AMENDMENT OF SOLICITATION/MODIFICATION OF CONTRACT		BPA NO.	1. CONTRACT ID CODE	PAGE 1	OF PAGES 15
2. AMENDMENT/MODIFICATION NO. A00007		3. EFFECTIVE DATE 10-15-2015	4. REQUISITION/PURCHASE REQ. NO. 675-16-1-3252-0001	5. PROJECT NO.(If applicable) 615-14-150	
6. ISSUED BY Department of Veterans Affairs Orlando VA Medical Center 5201 Raymond Street Orlando FL 32803		CODE	7. ADMINISTERED BY (If other than Item 6) Department of Veterans Affairs Network Contracting Activity 8 (NCO 8) Orlando VA Medical Center 5201 Raymond Street Orlando FL 32803		CODE 00675
8. NAME AND ADDRESS OF CONTRACTOR (No., street, county, State and ZIP Code) To all Offerors/Bidders			(X)	9A. AMENDMENT OF SOLICITATION NO. VA248-15-R-2022	
			X	9B. DATED (SEE ITEM 11)	
				10A. MODIFICATION OF CONTRACT/ORDER NO.	
				10B. DATED (SEE ITEM 13)	
CODE		FACILITY CODE

Request for Information (RFI) Tracking Log
Solicitation: VA-248-15-R-2022
Project: 675-14-150
Title: Renovate Laboratory and Radiology Department
RFI Tracking Log RFI# 1-58
10/15/2015

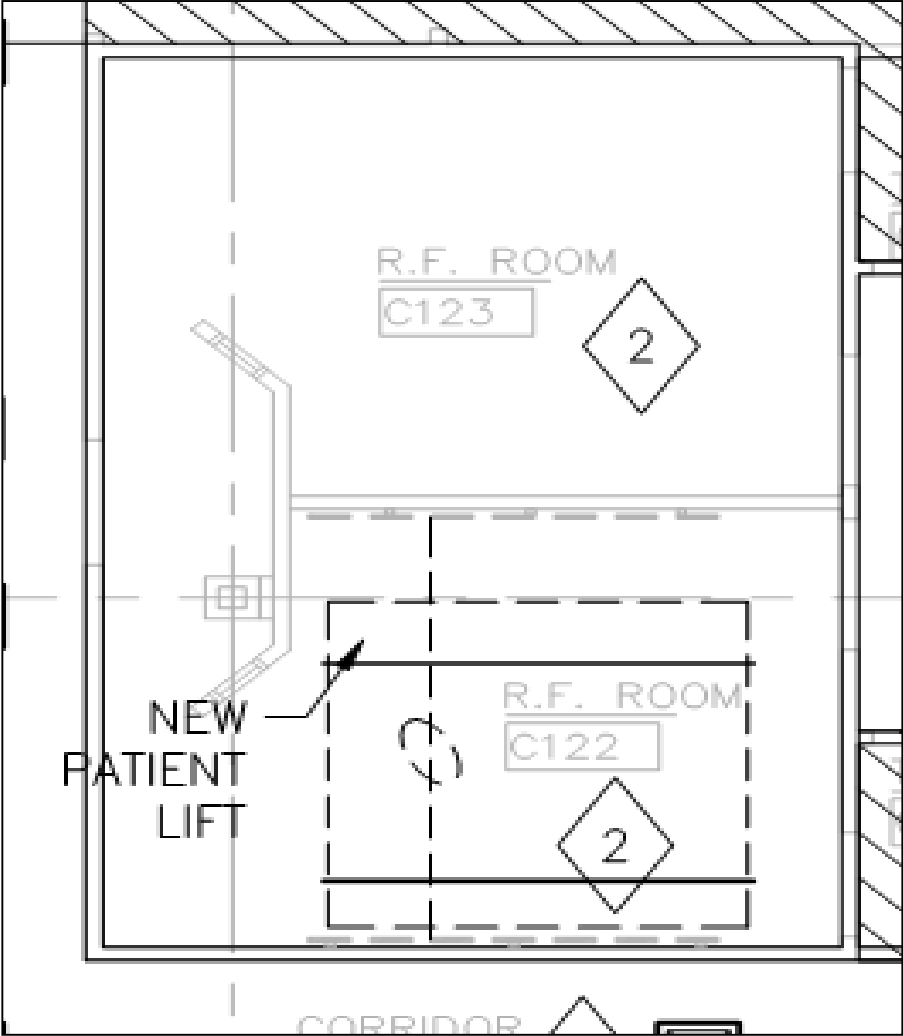
11	<p>6. Are we correct in assuming that RF equipment supports are existing in place in Rooms C19, C122, and C125? See sketch below.</p> 	Contract & Purchasing Solutions	10/01/15
Reply	<p>We would like clarification on question #6 below: Your RFI #6 references RF Equipment supports” but the RF Equipment is only in Room C122. The other two rooms are Ultrasound and Gamma – Did you mean “lift” equipment supports? And we assume C19 is room C119. There is no longer a lift in room C122 – it is now in the hallway outside the room. See response to RFI #3.</p>		
12	<p>6. Provide additional details as to how the patient lift and supports will integrate with the existing RF equipment in Room C122. Also, please confirm if Rooms C119 and C125 are included in the patient lift scope of work.</p>	CPS	10/05/15

Reply	See answer to RFI #3 and RFI #11.		
13	Upon review of the above referenced solicitation, we have noticed that Evaluation Factor 2 (pg. 17) requires the “prime contractor shall provide a valid General Contractor’s License”. Does this need to be a General Contractors License specifically issued by the state of FL, or will another state suffice as long as it is a “valid GC license”?	G&C Fab-CON	10/06/15
